1 Introduction

This application note introduces the i.MX 8M Nano with replacement new package (UC type) by highlighting the differences from the original discontinued package (VT type). The original part number is discontinued and replaced with new part marking and new orderable part numbers. This migration guide is useful for the i.MX 8M Nano developers that migrate from the discontinued VT package to the replacement UC package.

Document identifier: AN13416

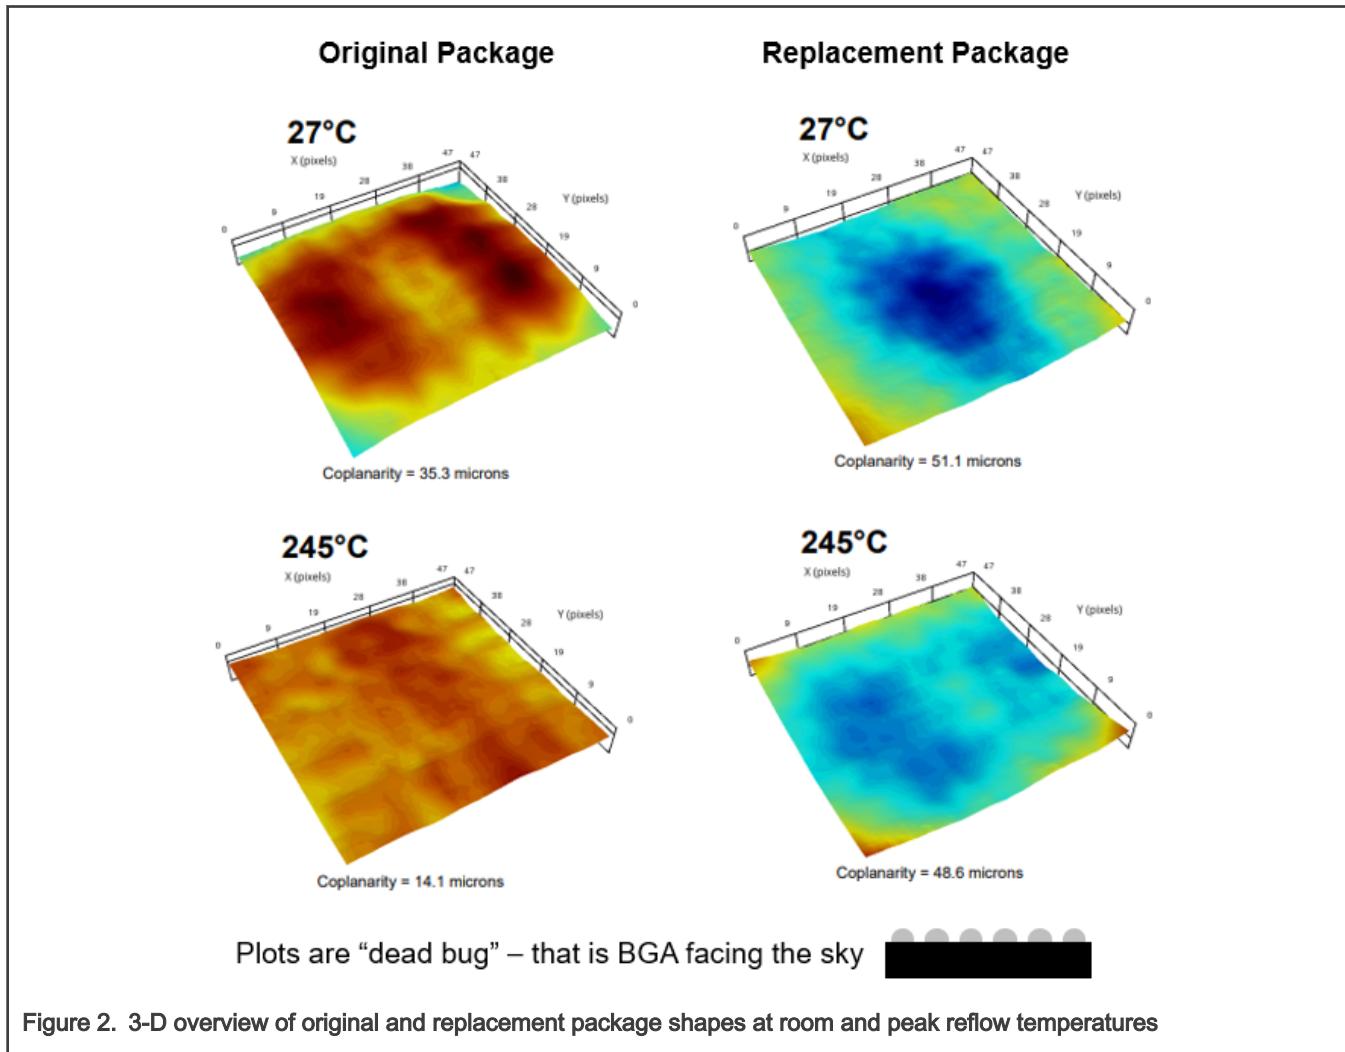
Compared to the discontinued package, the thinner replacement package contains a different characteristic shape at solder reflow temperatures, as shown in [Figure 2](#). Certain PC board designs using soldermask defined pads may experience soldering issues with the replacement package. For more details and recommendations, see [Board assembly](#).

Figure 4. Illustration of solder “squeeze-out” with SMD pad design

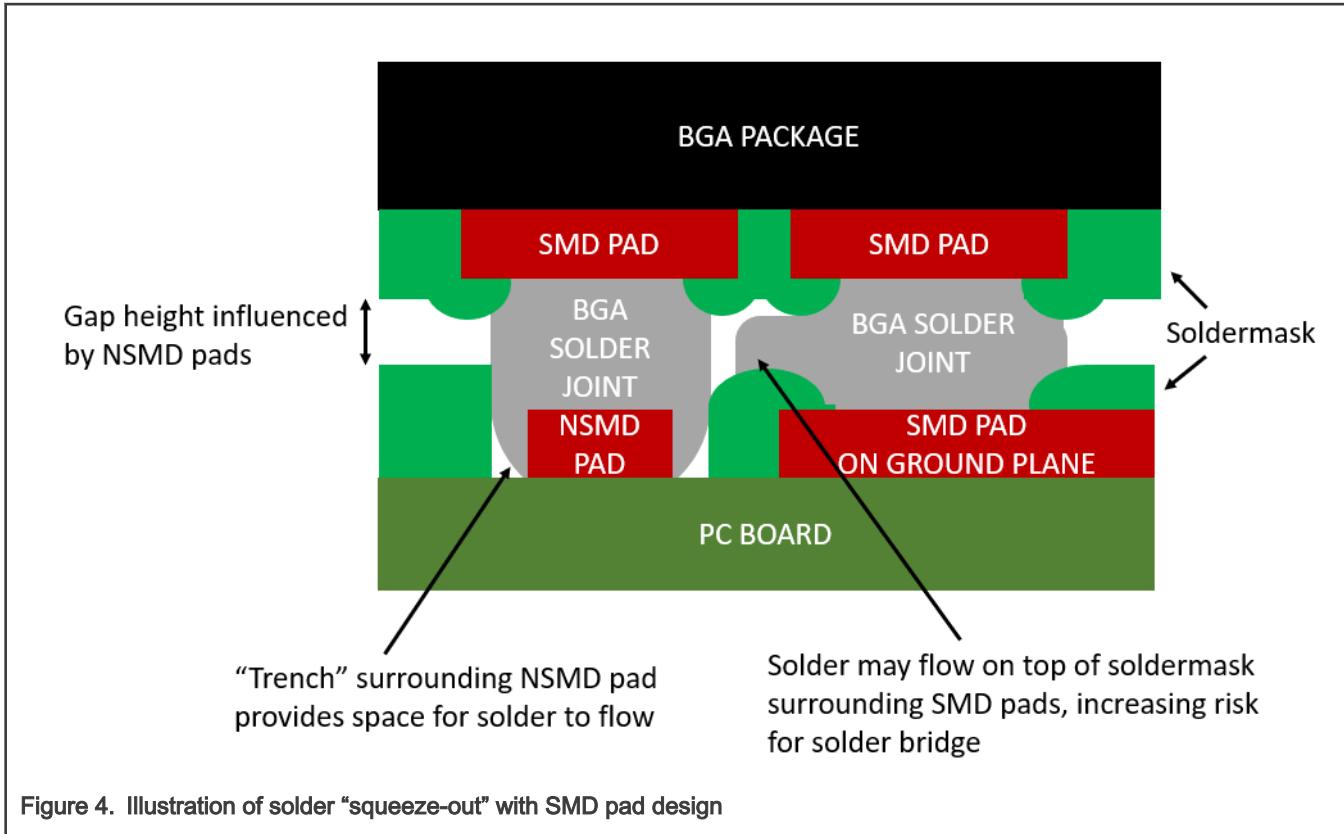
SolderMask Defined (SMD) or a mixture of NSMD and SMD PC board pads are not recommended because the SMD design can cause solder to flow on top of the soldermask surrounding the pad, potentially resulting in solder bridging, as illustrated in [Figure 4](#).

Understandably, the preference is often to create an SMD pad over ground planes for electrical and design simplicity motivations. As illustrated above, this may increase the risk of solder bridging. NXP recommends to use a **ground plane relief** design where an opening is created in the plane for placement of an NSMD pad, as shown in [Figure 5](#). The pad is connected to the plane by multiple metal lines. This design maintains the **trench** around the pad to capture molten solder that may be pushed out during the dynamic package bending during reflow. The recommended feature sizes for this NSMD pad design are:

- 0.250 mm round pad
- 0.330 mm round SRO opening
- 0.420 mm diameter **hole** in Cu plane
